Carbon Fibre in Pulpits and Stanchions

Public Comment

Final Recommendations

WP Project Managers:
Fred Barrett (Naval Architect)
Glen Stanaway (Yachting Australia)

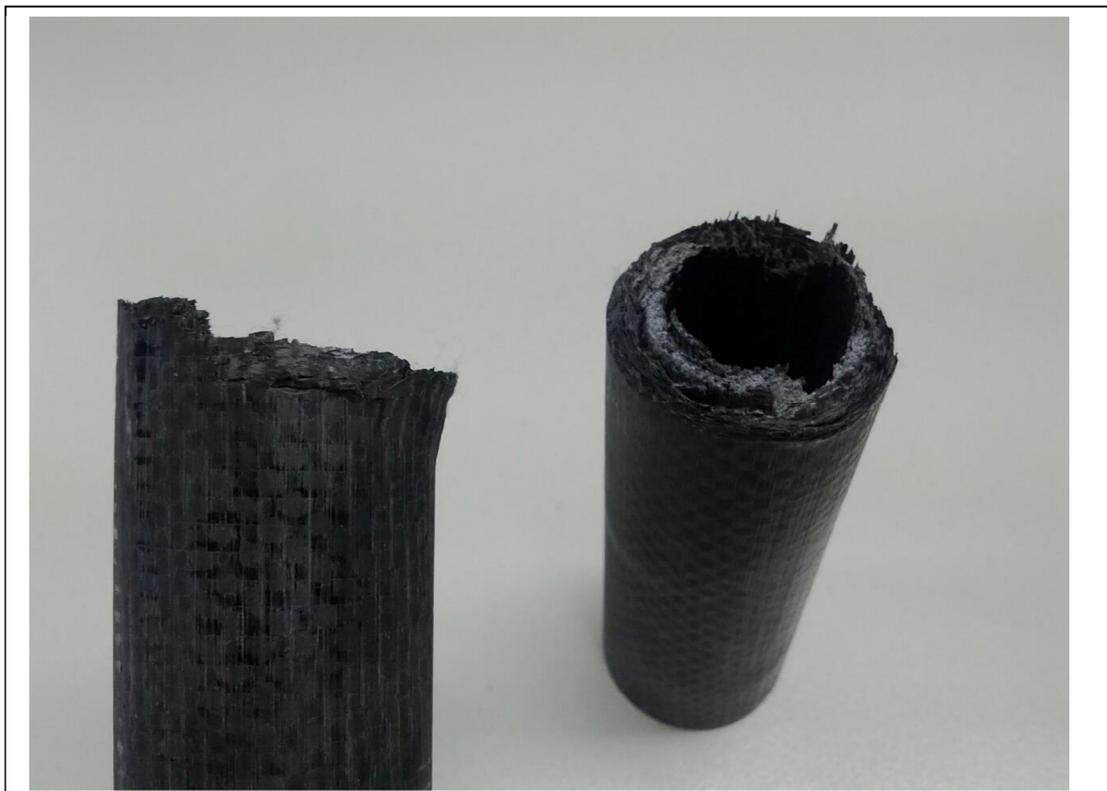
Stainless Steel. The tear can be seen in the middle of the fold. Straightening the stanchion risks breaking the stanchion in half.

Stainless Steel. The stainless steel has deformed significantly.

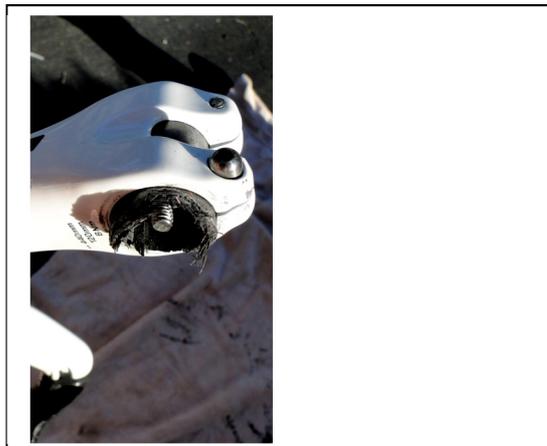
E-glass. Rough tears can be seen where the break has occurred. This is evident on the full circumference of the stanchion.

E-glass. Closer viewing shows velar vertical splits in the E-glass.

Carbon fibre/E-glass. Rough tears can be seen where the break has occurred. This is evident on the full circumference of the stanchion.

Carbon fibre/E-glass. Closer inspection shows the rough edges.
